# Product Change Notification

**Change Notification #:** 119229-00

**Change Title:** Intel® Server System R2312WFTZSR, PCN 119229-00, Product Design, Label, Product Material, Changes Impacting Server Board and HSBP

**Date of Publication:** August 19, 2022

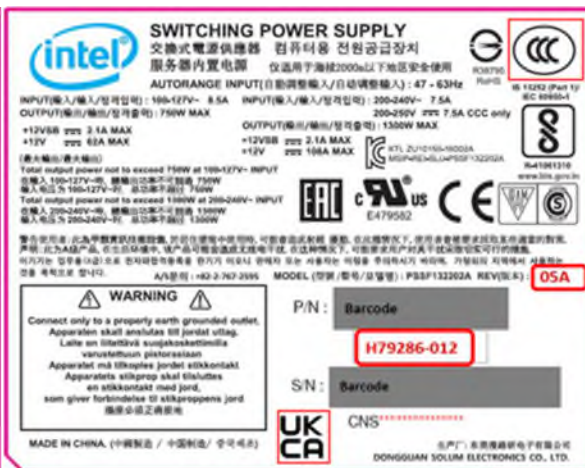
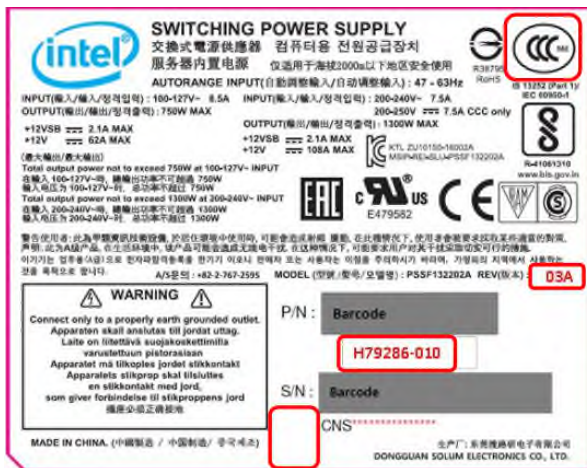
- Updating the 1300W Power supply:
  - Adding the UKCA mark and removing S&E from CCC logo on the label
  - Firmware upgrade from 26.5.128 to 29.5.128 and a minor hardware change, there is no impact on functionality.

Please note that the latest part number of the PSU including these changes is H79286-012.
